# National Transportation Safety Board

## Safety Recommendation

**Date:** March 30, 2006

**In reply refer to:** A-06-29 through -35

**Figure 1.** Burned area beneath the left forward cabin floor of the ASA CRJ-200.

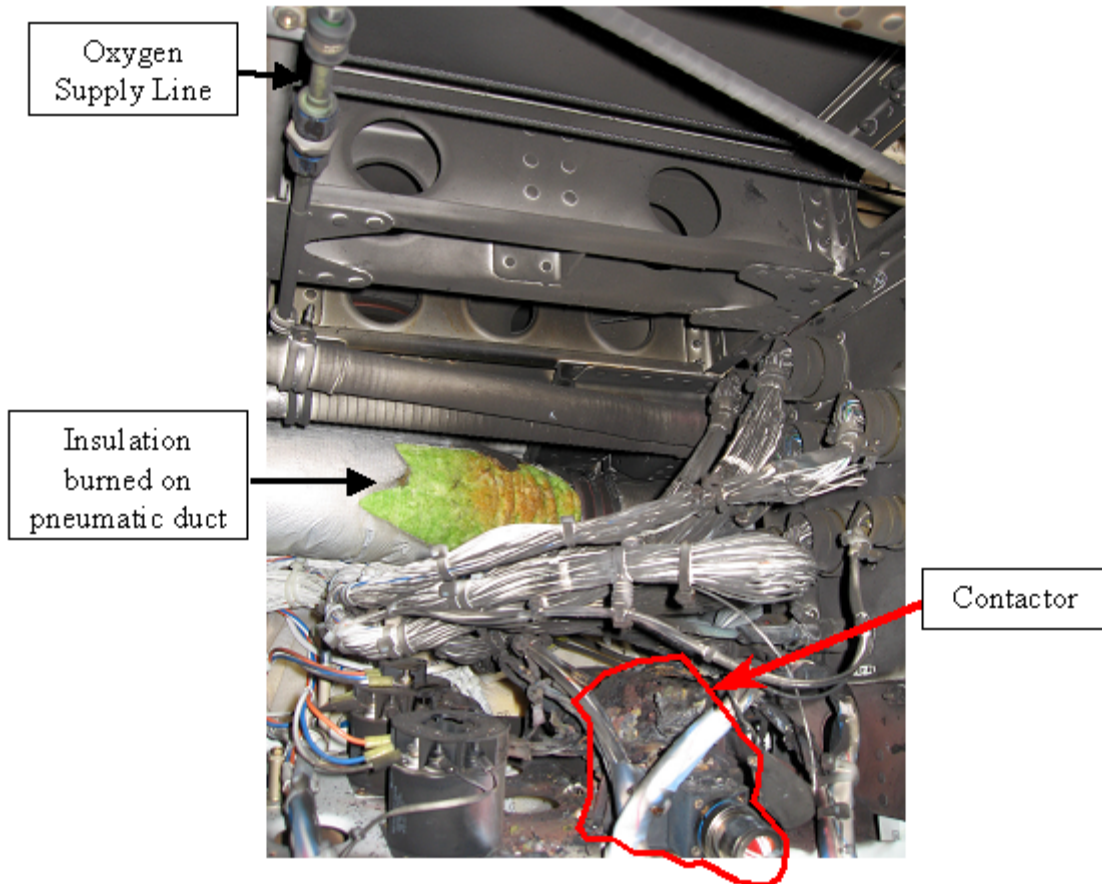
On December 14, 2005, the pilots of Atlantic Southeast Airlines (ASA) CRJ-200 flight 5029 declared an emergency while descending through 24,000 feet into Hartsfield-Jackson Atlanta International Airport, Atlanta, Georgia, when a fire broke out at the 1K4XD contactor in the avionics compartment (see figure 1). The cockpit voice recorder (CVR) transcript revealed that the flight crew was confronted with a cascade of failure events as electrical power from the left, and then right, generator was lost, the smell of electrical smoke entered the cockpit, all EFIS displays were temporarily lost, the cabin temperature temporarily became hot, and the air-driven

generator (ADG) deployed.<sup>3</sup> The crew only had use of the single standby flight reference instrument when the surrounding EFIS displays began to flicker. The CVR transcript indicated that the flight crew had difficulty prioritizing which checklists to use to respond to the numerous visual and aural alerts and warnings, and the flight crew did not completely follow any single checklist. Similar to the December 8 event, postincident inspection of the airplane found that the captain's oxygen supply line was blackened.

**Figure 2.** Arcing and flames rising from the contactor base with the Ultem 2200 material after water bridged two electrical terminals. Continuous short-circuiting and fire, along with occasional arcs, such as shown above, lasted for 100 seconds in this test.

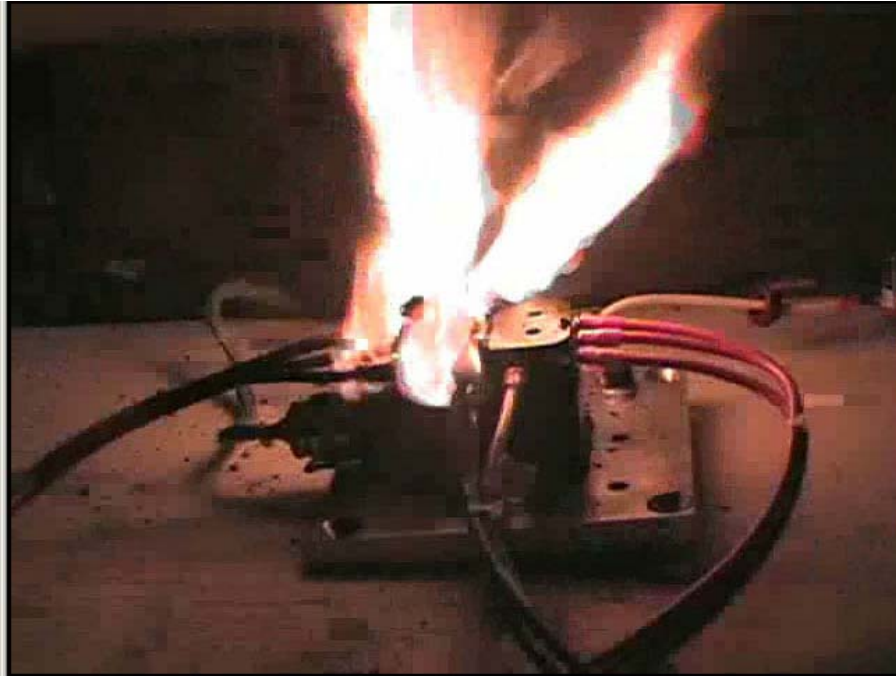
Two versions of the 1K4XD contactors are approved to be installed on in-service CRJ-200 airplanes: the originally certified version, which uses NP509 woven glass fabric, melamine resin laminate (also known as G-9) as an insulator for the contactor's plastic base and a newer version (approved for use on March 16, 2000, by Tyco Hartman<sup>5</sup>), which uses the Ultem 2200 material. Safety Board investigators conducted tests at Tyco Hartman on both versions of the contactor in February 2006. The tests revealed that when drops of water were placed on the contactor that contained the Ultem 2200 material to bridge the electrical terminals, the Ultem 2200 material gradually turned to a carbon char for the duration of power application. After the water evaporated due to the short circuit, the carbon char provided a semiconductive path between terminals, and intense flames and arcing extended more than a foot from the contactor (see figure 2). The duration of the breakdown of the base material, short-circuiting, and fire lasted for more than 100 seconds in one test before a wire fell away, disconnecting the power supply. Similar tests on the contactor containing the melamine insulator material resulted in the water steaming off with no material breakdown and no fire.

Immediately require Bombardier to develop a means of protecting electrical terminals on Tyco Hartman 1K4XD contactors fitted with Ultem 2200 (polyetherimide) terminal bases from moisture-induced short circuits. (A-06-30) Urgent

Require Bombardier to expedite the replacement of 1K4XD contactors on CRJ-200s with contactors that are not susceptible to short circuit. (A-06-32)
